Supplement Sheet

SUBJECT: Drive Cable Adjustment

MODEL AFFECTED: Self-Propelled
Model Series 18M

Figure 1

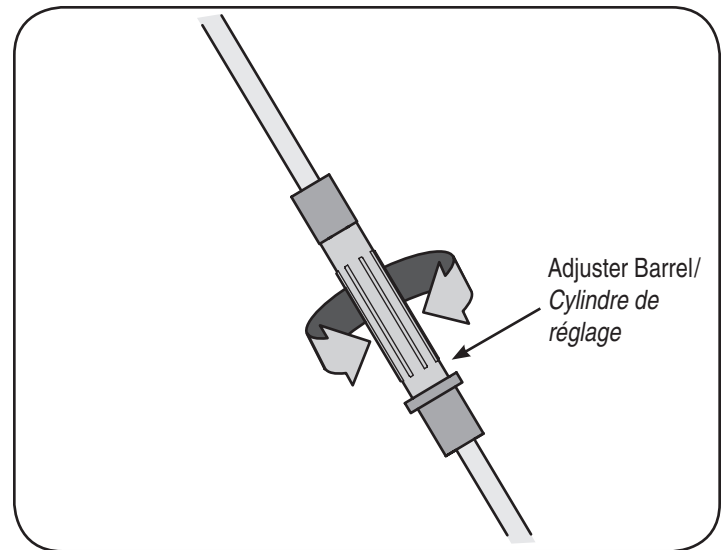
Your unit is equipped with an adjustable drive cable to adjust the tension on the drive cable. You will need to adjust the drive cable if the mower does not propel itself with the drive control engaged or if the mower's wheels hesitate with the drive control engaged. If either of these conditions occur, rotate adjuster barrel - making it longer will give more drive and shortening it will give less. This will also increase or decrease the force required to engage the drive control. See Figure 1.
